EPRI Reviewer (Jon Stewart)  
Comments on the  
Coherency Function

# EPRI Reviewer (Gail Atkinson) Comments on the CAV Model

## NRC RIAs for CAV (G1.2)

## CAV Model

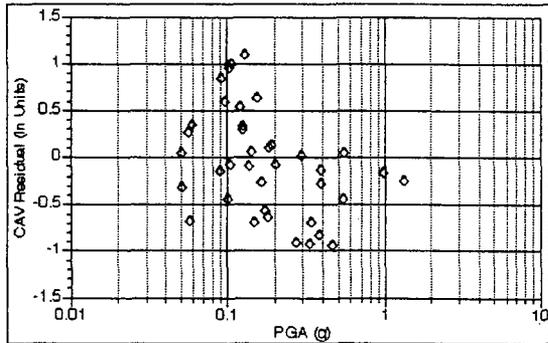
- CAV model goes through 2 steps using duration as an intermediate step. The model is complicated and is difficult to understand how the form of the model was selected. Can it be simplified?
  - Reason for including intermediate step with duration dependence was to allow for a duration difference between WUS and EUS, but no difference found for uniform duration
  - Form of model is based on exploratory analysis and previous models for other parameters with thresholds
  - Model could be simplified which would make it easier to follow

## Residuals Including New EUS Data

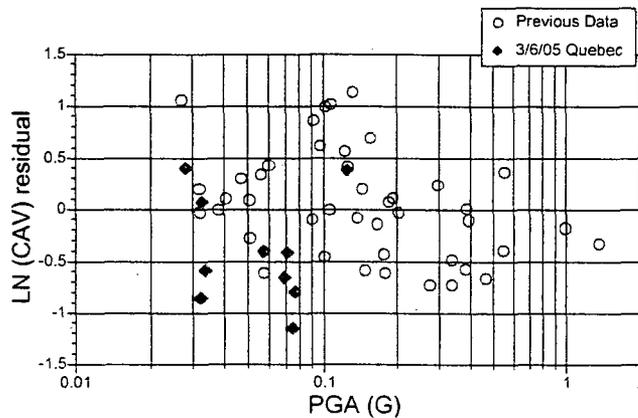
- Trend in EUS residuals vs PGA suggests that WUS model may not be applicable to EUS

WUS model is  
Conservative  
for  $PGA > 0.2g$

Mean = -0.03

## NRC RAIs for CAV

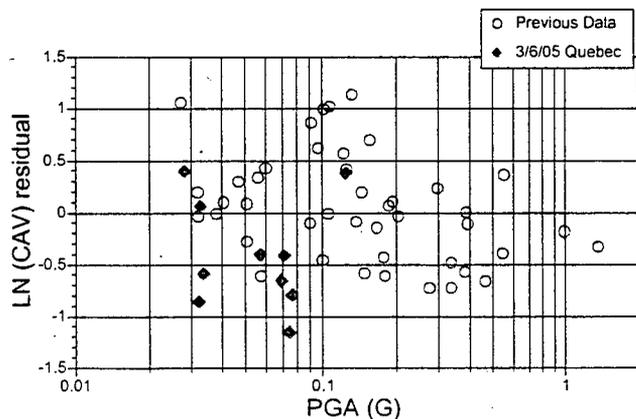
- 3a. The residuals are the estimates of experimental error.
  - The residuals are not experimental error. They represent the variability of CAV that results when a few simplified parameters are used as predictive parameters.
- 3b. How are the CAV distributions with respect to uniform durations and PGAs for the CEUS?
  - Not clear of the question. Residuals shown for EUS CAV as function of duration and PGA
